**SENIOR LEADER IN-TRANSIT COMFORT
CONFERENCE CAPSULE (SLICC)
PROPOSAL FOR
AIR MOBILITY COMMAND**

November 15 2006

DRAFT

DRAFT SLICC PROPOSAL

APPENDIX 1 SLICC NOTIONAL CONFIGURATION

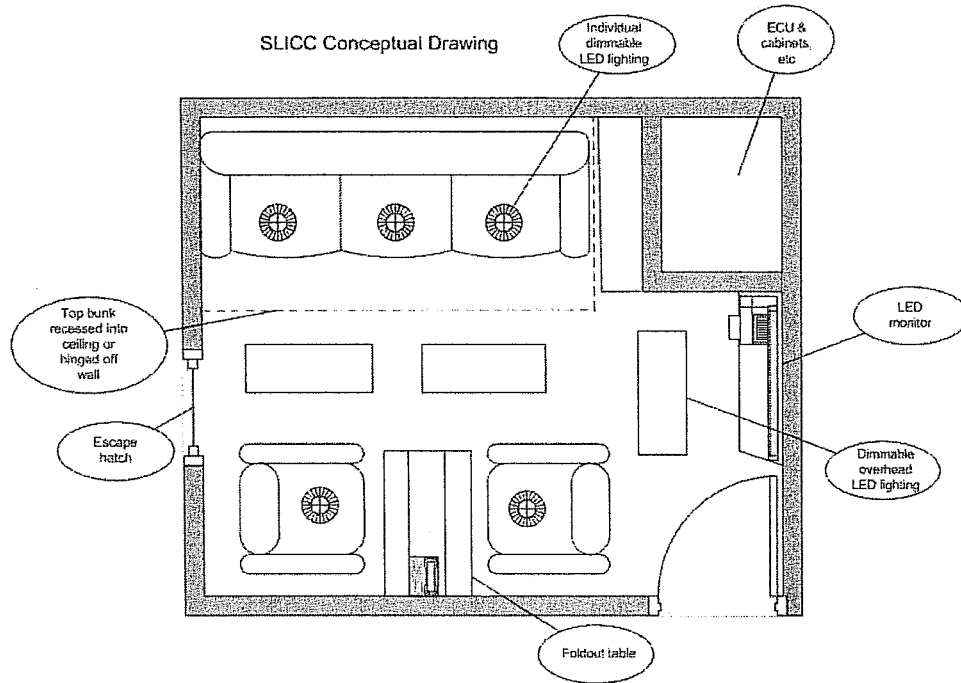
Comment [gh3]: The location of the display screen is limited view for the couch occupants. Consider moving to location between chairs if this could be done without interfering with fold-out table. Would also provide a place to put laptops when using display screen to show briefings.
